ADDENDUM

RFB NO. 317012 - ADDENDUM NO. 1

DAY RESOURCE CENTER REMODELING

1 3.06 DEMONSTRATION

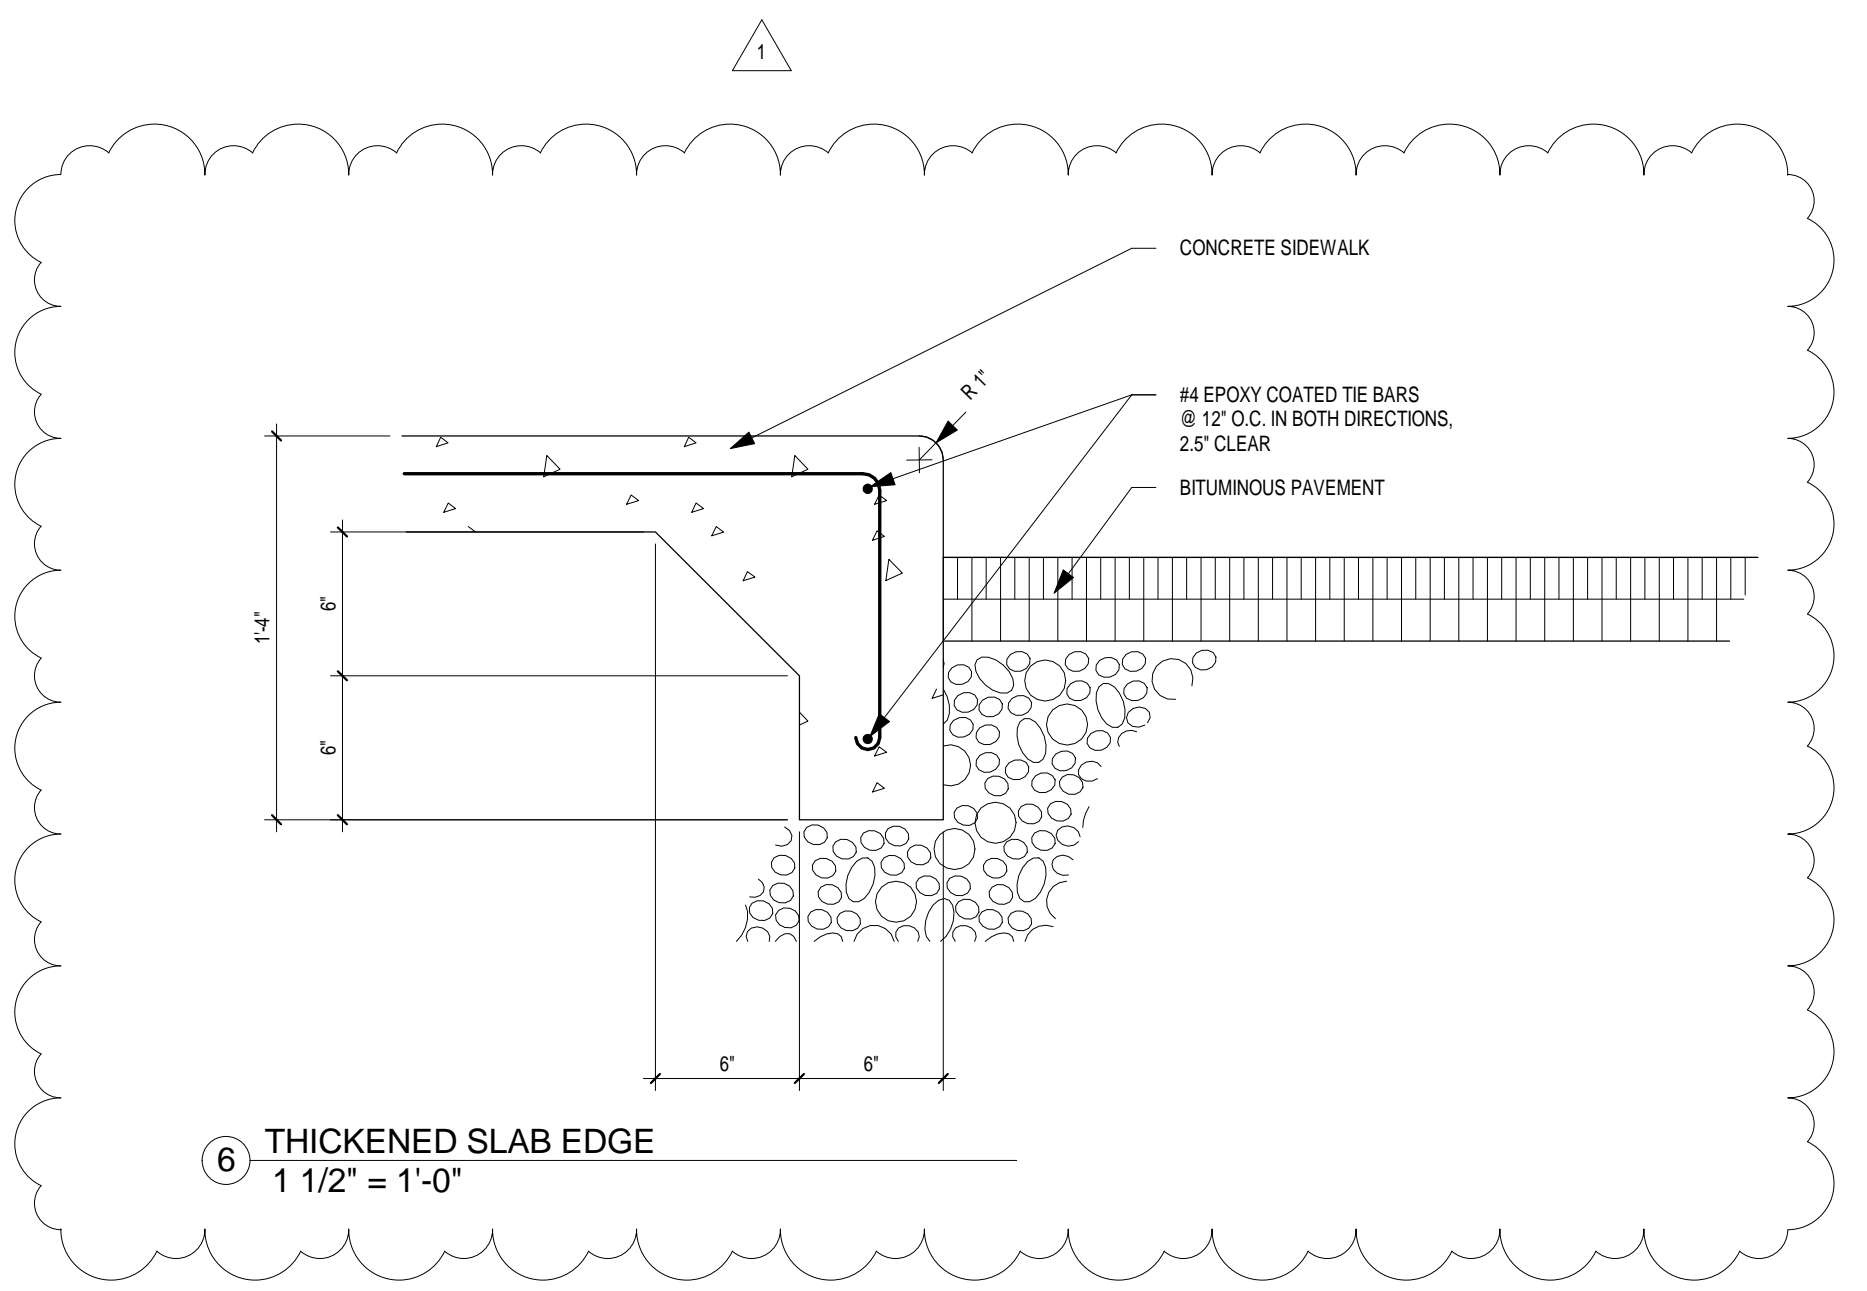
- b. Second Floor Resource Center 205: “Extend soffit at exposed structure plan north approximately 2’-0”, V.I.F. to conceal ductwork.”
6. A600
 - a. Refer to attached revised A600 for revised covered fence detail and additional concrete walk detail (Alternate Bid A).

DRAWING
FIRST AND SECOND FLOOR
PLUMBING PLANS

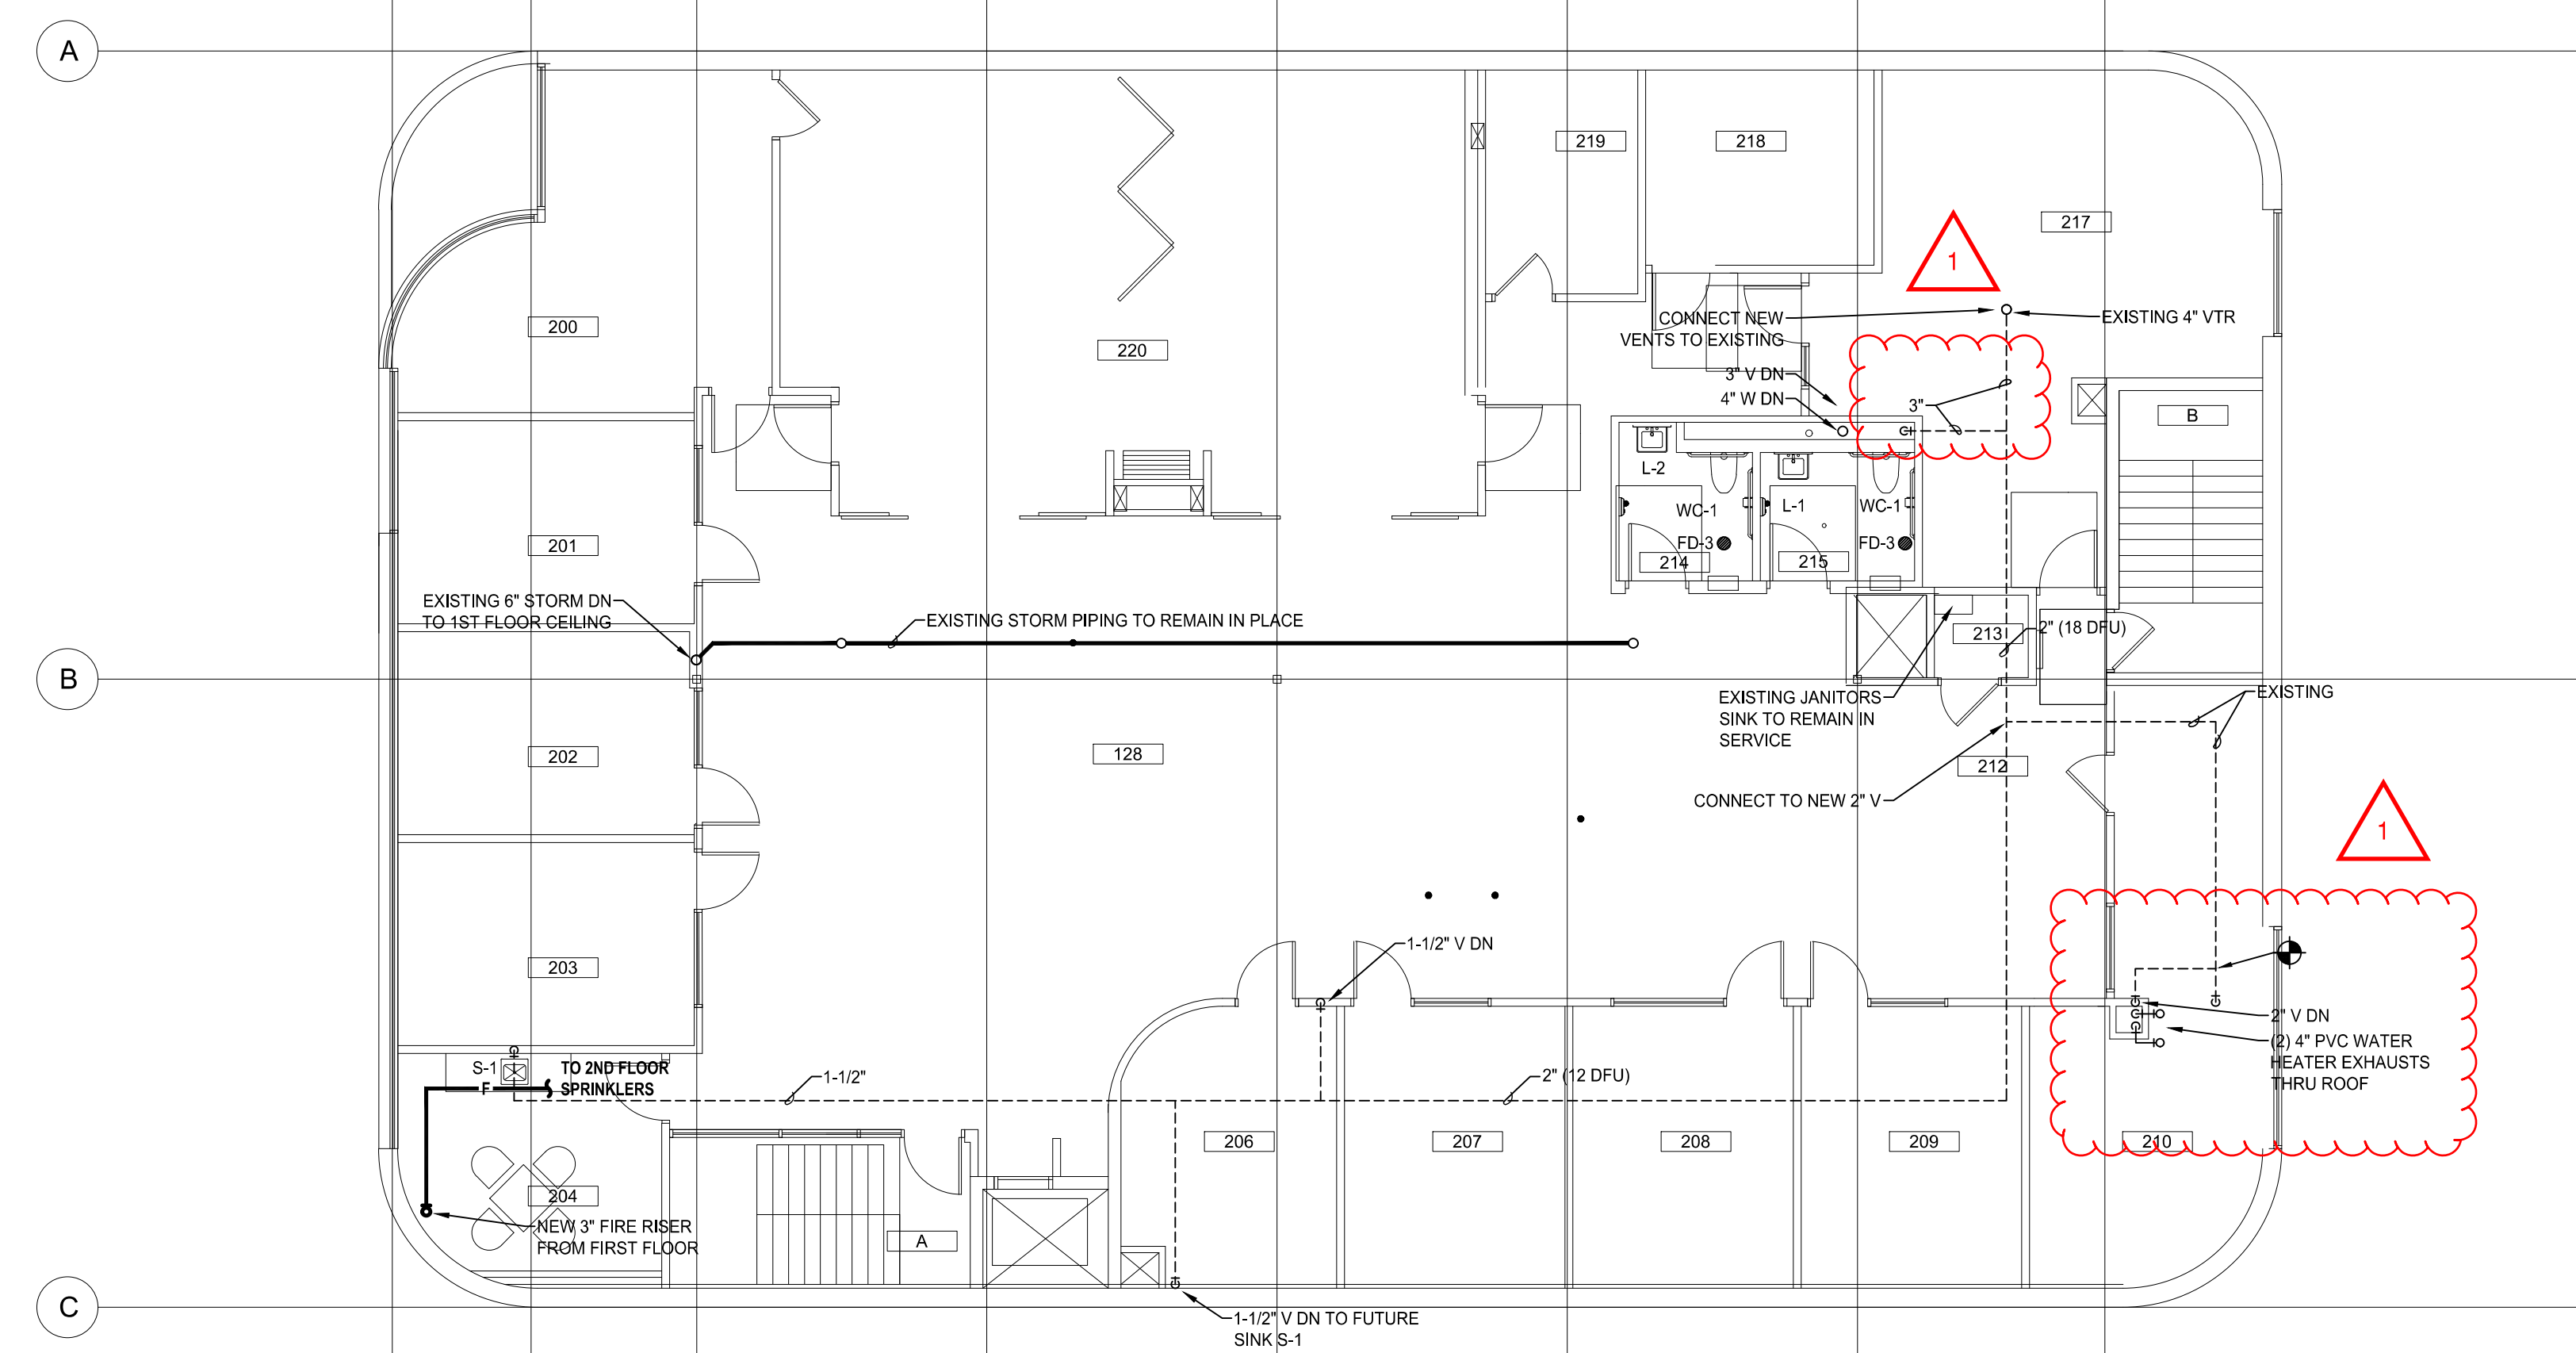
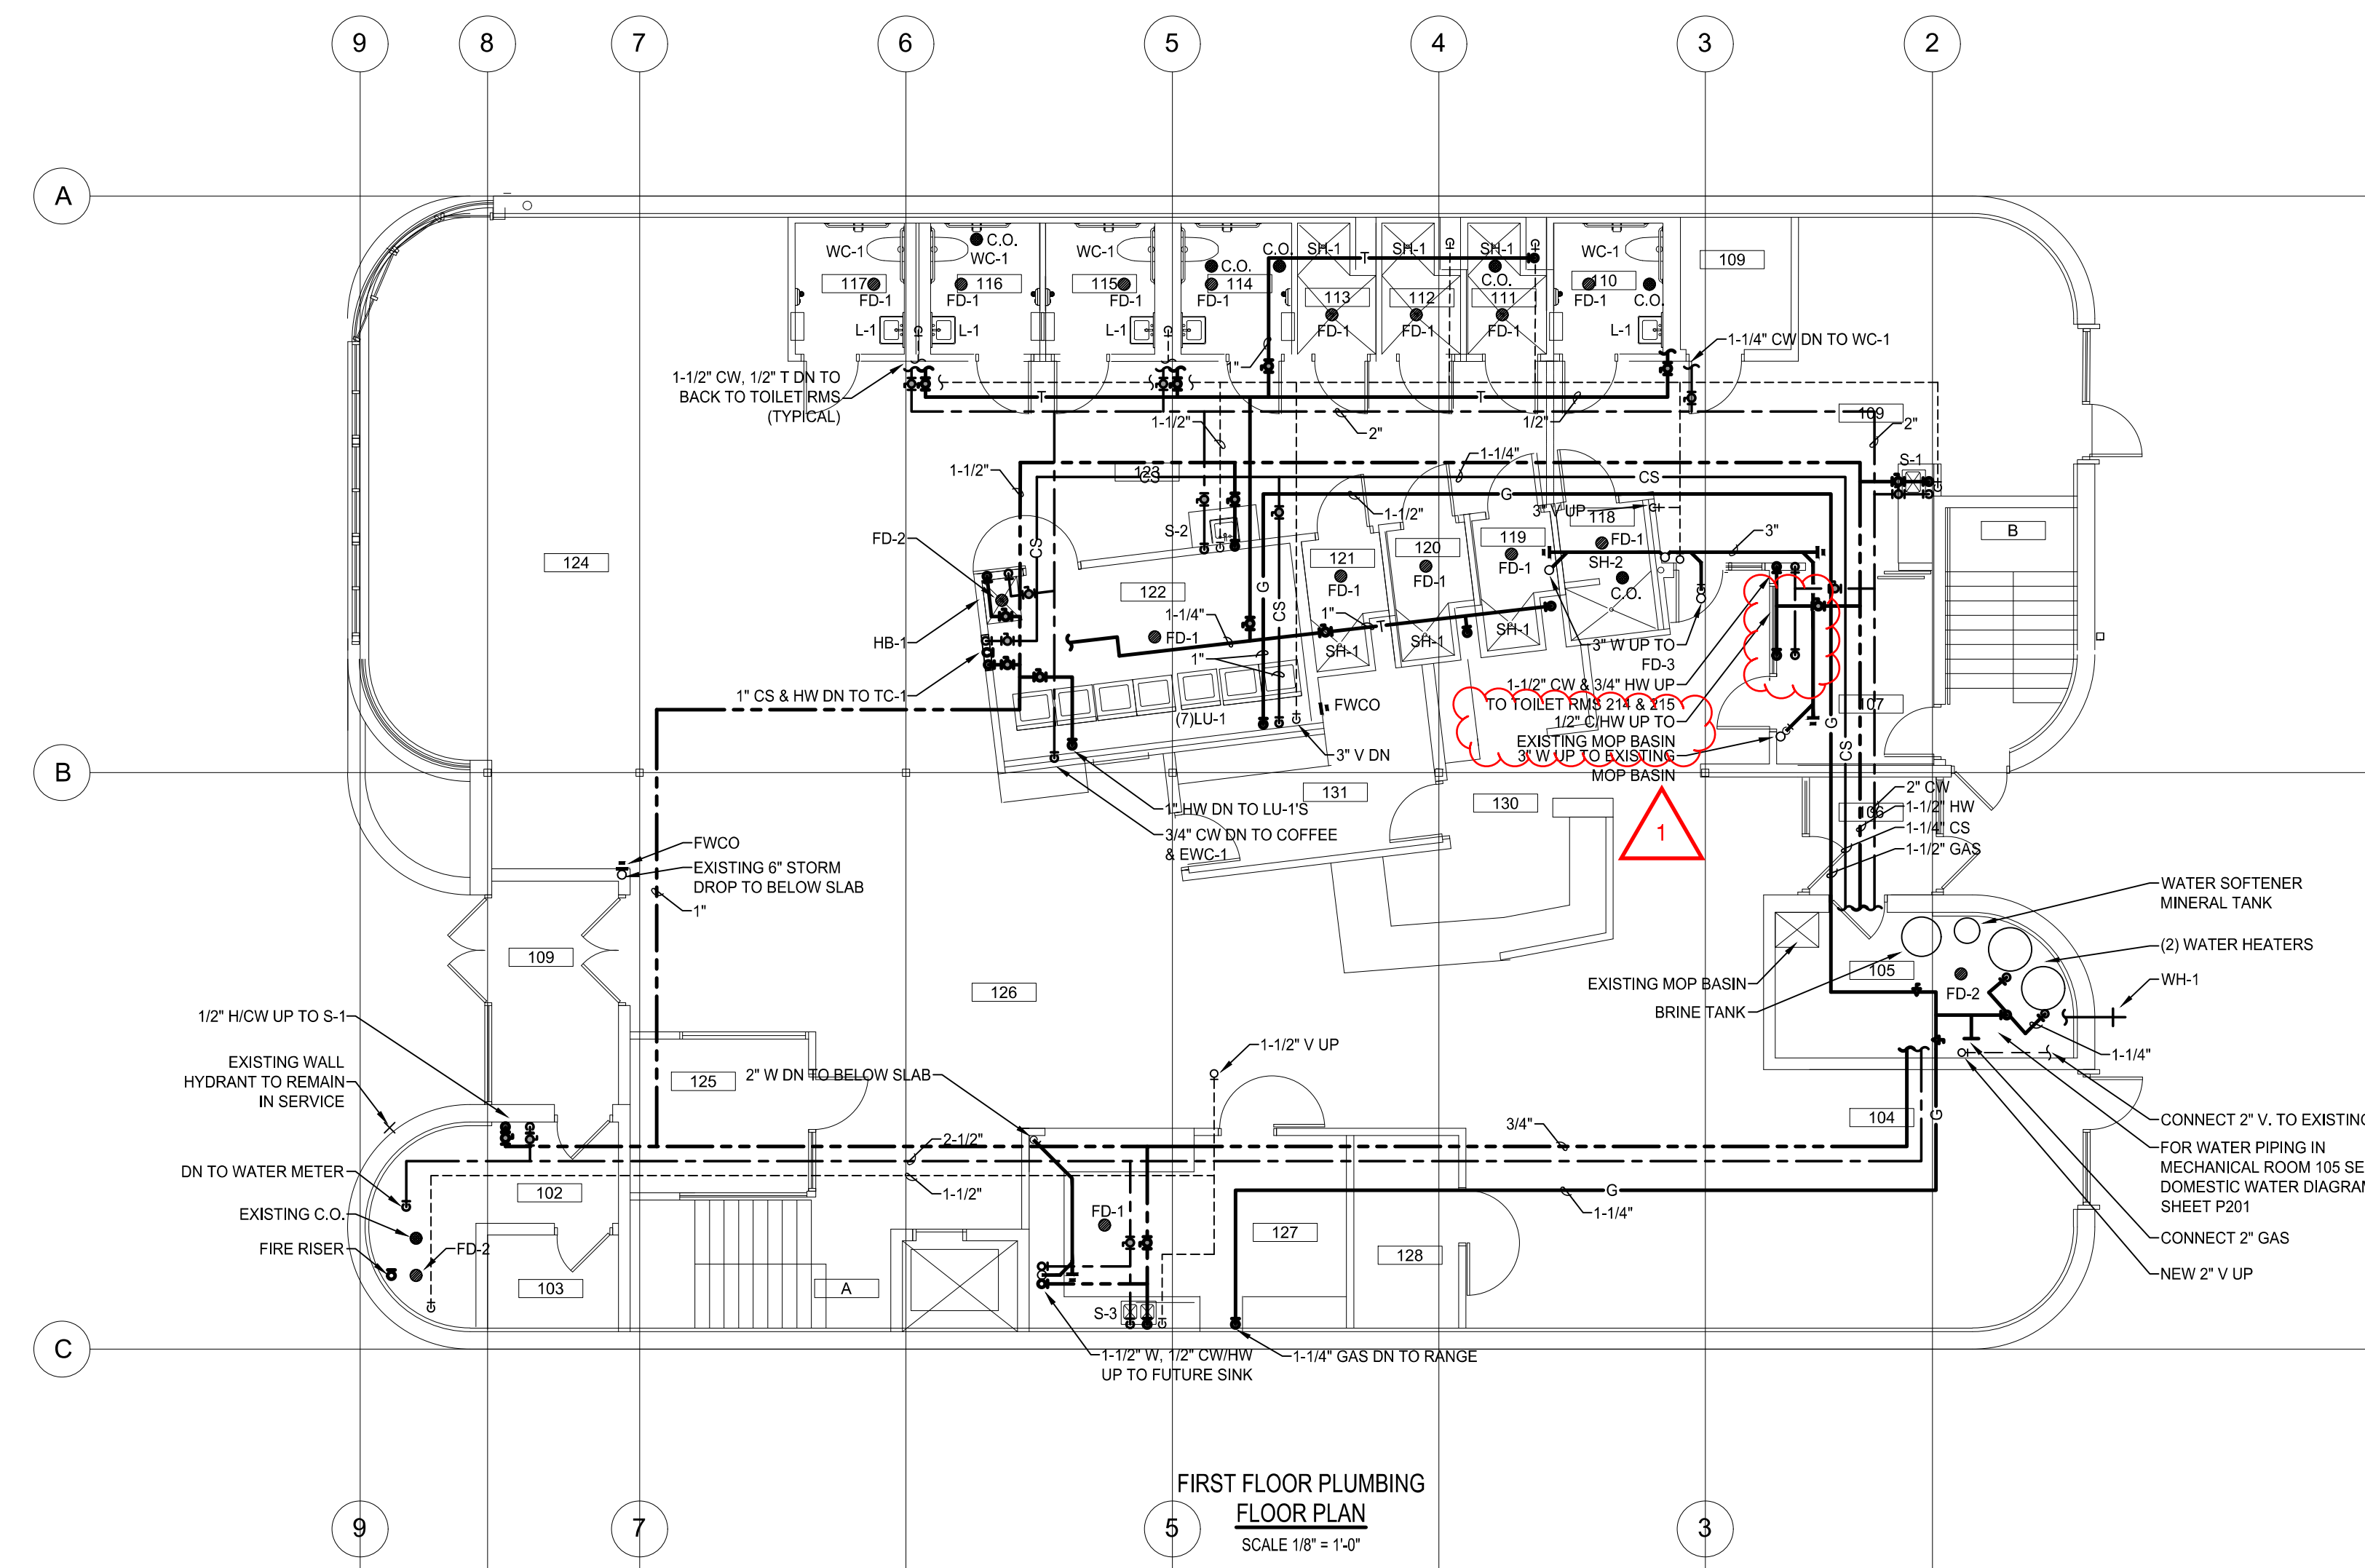
- 12. Sheet P100
 - a. In room 102, add 2" size to branch drain that serves sink S-1 at second floor.
 - b. Adjacent room 127, change note that reads, "1-1/2" W up", to read, "1-1/2" V up".
